**IEEE P802.11
Wireless LANs**

**Comment resolutions for Reference Model and MLO
Architecture**

This submission proposes resolutions for following CIDs received for TGbe D6.0:

Figure 4-33c—High level structure for AP MLD with affiliated APs (#23012, #23159)

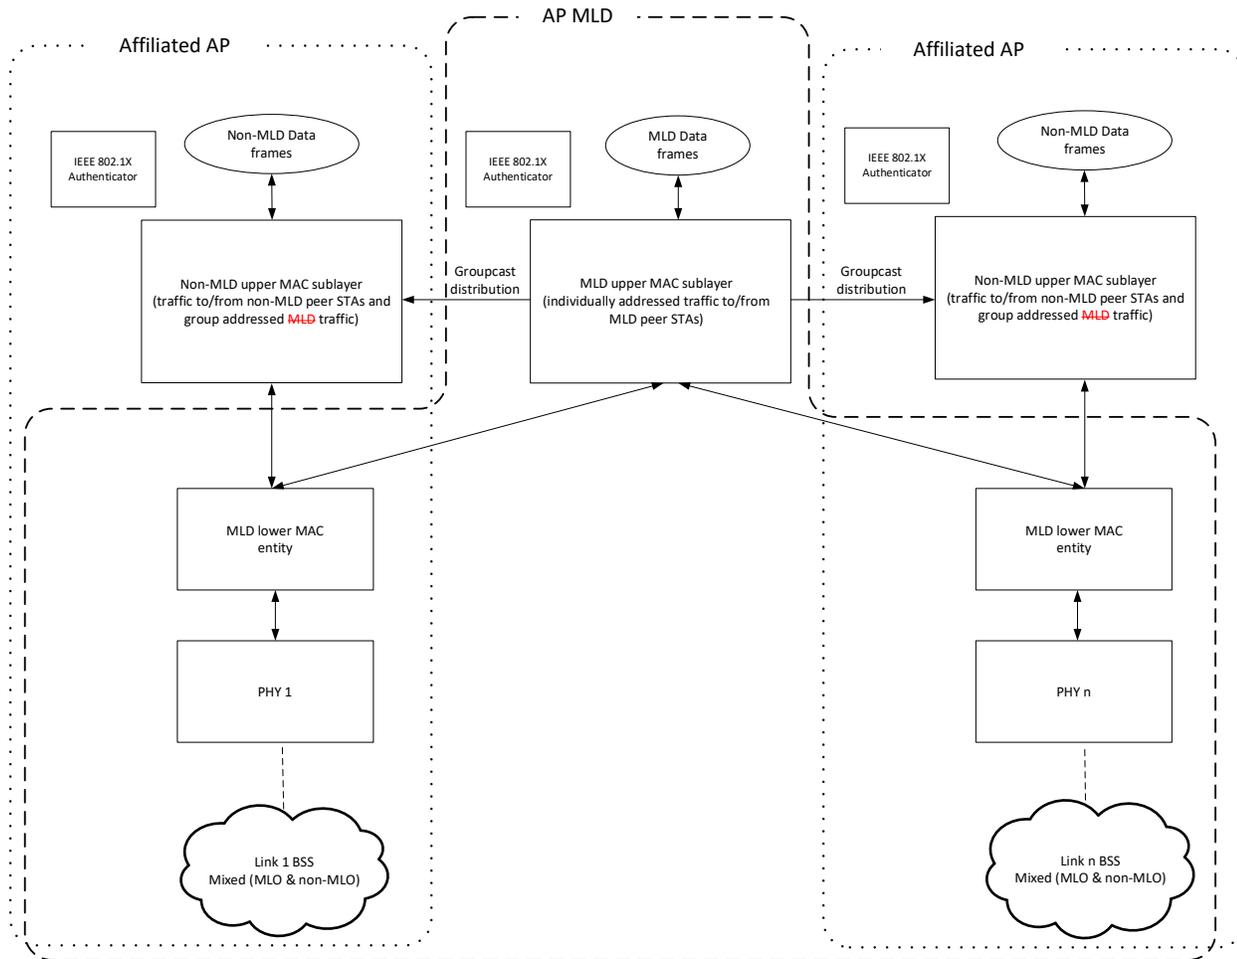
23013	Binita Gupta	4.9.6	78.40	<p>In this clause and in Figure 4-33c, it is not clarified whether the group addressed MLD traffic is first received by the MLD Upper MAC layer and then sent to the non-MLD upper MAC for link specific encryption of groupcast MLD traffic. Figure 4-33c does not show how the groupcast MLD traffic is received by the non-MLD upper MAC. P83L64 specifies that group addressed traffic is first received by the AP MLD.</p>	<p>Clarify how the groupcast MLD traffic is received by the Non-MLD upper MAC in Figure 4-33c and in the text on P77L64.</p>	<p>Revised.</p> <p>Agree with the commenter in that there is an inconsistency in Figure 4-33c. To fix that inconsistency, the proposed resolution is to remove the word “MLD” within the wording “group addressed MLD traffic” from two boxes “Non-MLD upper MAC sublayer” in Figure 4-33c. The rationale is that there is no need to have distinction as “group addressed MLD traffic” versus “group addressed non-MLD traffic.”</p> <p>To clarify the flow of the groupcast traffic from the AP MLD to the affiliated APs, the proposed resolution is to add two arrows from the box “MLD upper MAC sublayer” to the two boxes “Non-MLD upper MAC sublayer” (one on right and one on left) along with the associated text “Groupcast distribution” in Figure 4-33c.</p> <p>How the groupcast traffic is distributed to the affiliated APs from the AP MLD is local to the implementation. To add further clarity, the proposed resolution is to add the following text as a note after P84L07 in subclause 5.1.5.1:</p> <p>“How the AP MLD distributes group</p>

23158	Brian Hart	4.9.6	78.06	This is an evolution of CID 22291 that only partially addressed the concerns raised. Figure 4-33c is unusually unhelpful since it is unmoored to any SAPs.	Add SAPs at top of fig 4-33c, for affiliated APs and AP MLD.	<p>Rejected.</p> <p>The SAPs for affiliated APs and AP MLD are already shown in Figures 4-33a, 4-33b, and 5-2b. Hence, there is no need to overcrowd Figure 4-33c.</p>

23159	Brian Hart	4.9.6	78.15	<p>This is an evolution of CID 22291 that only partially addressed the concerns raised. In Fig 4-33c, groupcast is only shown as appearing within the non-MLD upper MAC sublayer which is misleading and incomplete, since the MLD upper MAC sublayer is responsible for assigning SNs.</p>	<p>Either (non-preferred) 1a) append "(for individually address frames)" to the caption and 1b) remove "and group addressed MLD traffic" x2; or (preferred) 2a) add a line labelled "Groupcast dissemination" from partway down the "MLD upper MAC sublayer" box to partway down the "non-MLD upper MAC sublayer" box x2, 2b) change "Non-MLD Data frames" ellipse to "Non-MLD individually addressed Data frames" ellipse x2 and 2c) change "MLD Data frames" ellipse to "MLD individually and group addressed Data frames" ellipse.</p>	<p>Revised.</p> <p>Agree with the commenter in that there is an inconsistency in Figure 4-33c. To fix that inconsistency, the proposed resolution is to remove the word "MLD" within the phrase "group addressed MLD traffic" from two boxes "Non-MLD upper MAC sublayer" in Figure 4-33c. The rationale is that the non-MLD upper MAC sublayer of an affiliated AP handles both MLD and non-MLD group addressed traffic.</p> <p>The solution in 2a) is preferred to that in 1a) and 1b).</p> <p>For 2a): Agree with the commenter in principle. To clarify the flow of the groupcast traffic from the AP MLD to the affiliated APs, the proposed resolution is to add two arrows from the box "MLD upper MAC sublayer" to the two boxes "Non-MLD upper MAC sublayer" (one on right and one on left) along with the associated text "Groupcast distribution" in Figure 4-33c.</p> <p>Furthermore, how the groupcast traffic is distributed to the affiliated APs from the AP MLD is local to the implementation. To add further clarity, the proposed resolution is to add the following text as a note after P84L07 in subclause 5.1.5.1:</p> <p>"How the AP MLD distributes group</p>

<p>addressed frames to the affiliated APs and coordinates the preparation of these frames for transmission is implementation specific.”</p> <p>TGbe Editor: please implement the changes shown in this document tagged as #23013.</p>
23146	Brian Hart	-	00.00	<p>This is an evolution of CID 22293 which was disposed of under the invalid reasoning that "However, performing all these changes does not fix any technical inconsistency since these [MIB variables] are internal variables and need not be exposed" which will come as a major surprise to the users of STAs that do expose these MIB variables (for decades). The STA statistics (under Dot11CountersEntry and Dot11QosCountersEntry) related to MSDUs, and arguably to MPDUs too, are defined at the link level but some parameters don't make sense at the link level - like dot11FrameDuplicateCount, dot11QosFailedCount, dot11QosRetryCount, dot11QosFrameDuplicateCount, dot11QosDiscardedFrameCount etc.</p>	<p>Address this inconsistency: e.g., a) redefine meaning to be at MLD layer in a non-AP MLO (but this solution is insufficient for an AP MLD due to legacy clients(?)), or b) create new MLD-level MIB variables for these kinds of parameters and then defined a new Measurement Req/Rep of type STA Statistics Report for MLD-level MIB variables.</p>	<p>Rejected.</p> <p>The comment fails to identify a specific issue to be addressed. It fails to identify changes in sufficient detail so that the specific wording of the changes that will satisfy the commenter can be determined.</p>

<p>addressed frames to the affiliated APs and coordinates the preparation of these frames for transmission is implementation specific.”</p> <p>For 2b): Non-MLD Data frames could be both individually and group addressed frames, which is captured by the current wording “Non-MLD Data frames.”</p> <p>For 2c): The current wording “MLD Data frames” is general enough to include both individually and group addressed frames.</p> <p>TGbe Editor: This is the same as comment resolution for CID #23013.</p>
--	--	--	--	--	--	---

TGbe Editor: Change Figure 4-33c below of subclause 4.9.6 as follows (#CID 23013):
